Permit of Authorization to Construct an On-Site Sewage Facility Permit Valid For One Year From Date Issued

Permit Number: 117696
Issued This Date: 08/22/2024
This permit is hereby given to: Christine K. Thompson

2167 GLENN DR
CANYON LAKE, TX 78133

Thank you for your submission. We have reviewed the planning materials for the referenced permit application, and unfortunately, they are insufficient. To proceed with processing this permit, we require the following:

RETAINING WALL SCHEMATIC

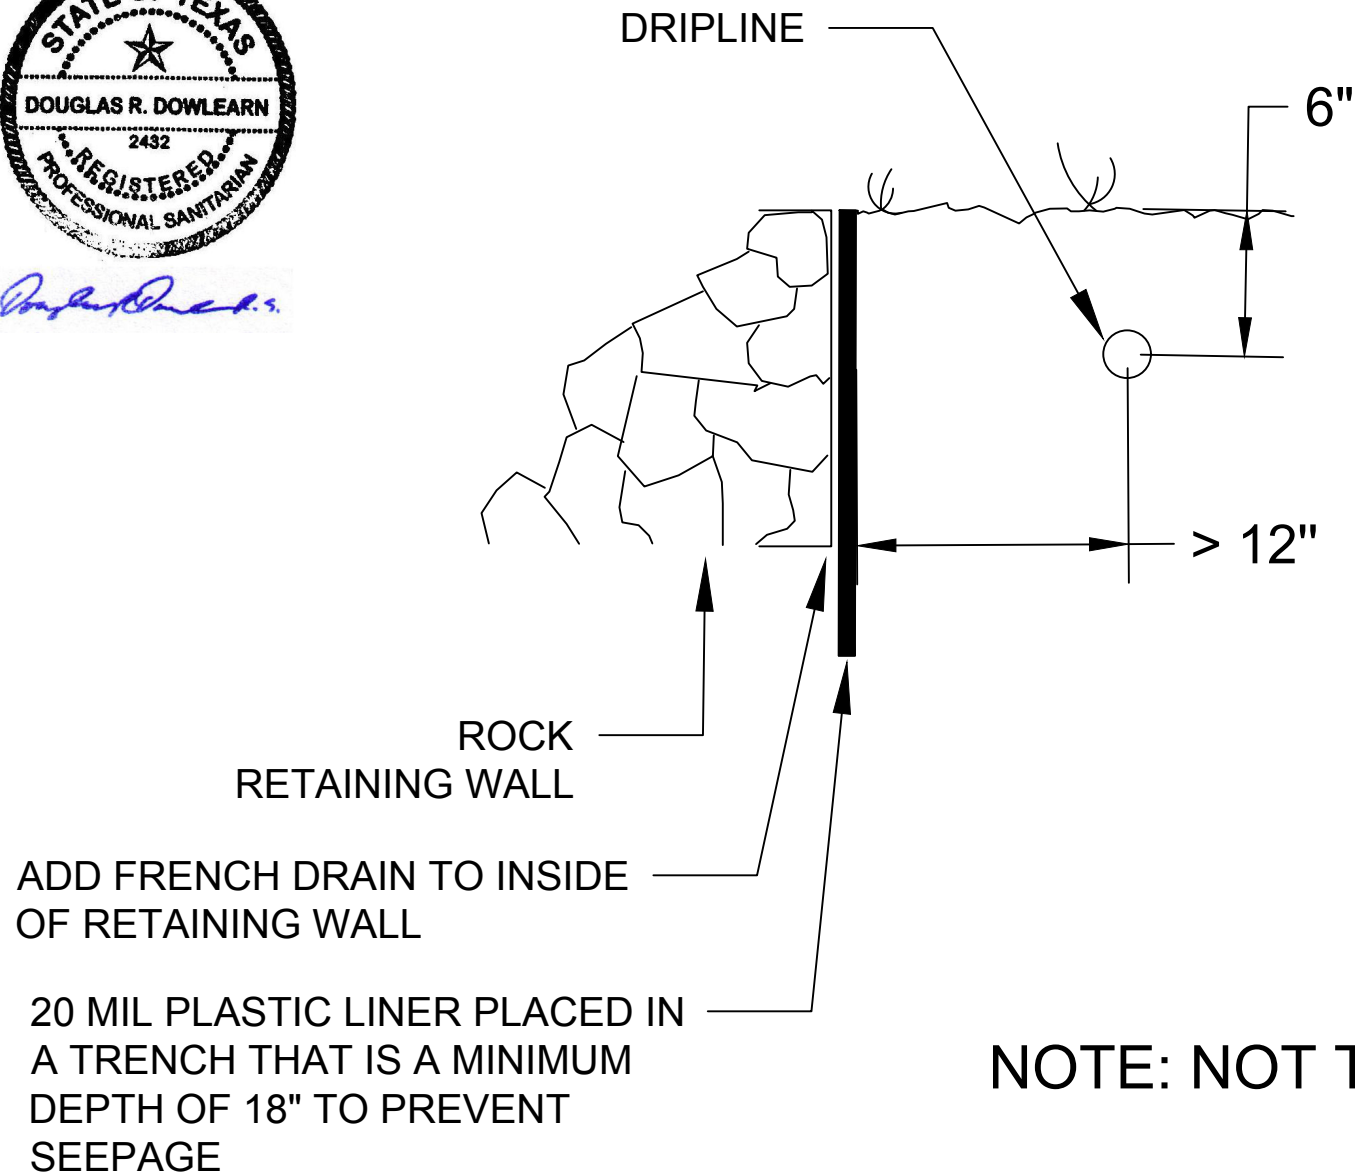
DRAINFIELD AREA SHALL BE REGRADED TO < 30% SLOPE

NOTE: LINE RETAINING WALL WITH 20 MIL. PLASTIC LINER TO PREVENT SEEPAGE - SEE VARIANCE REQUEST.
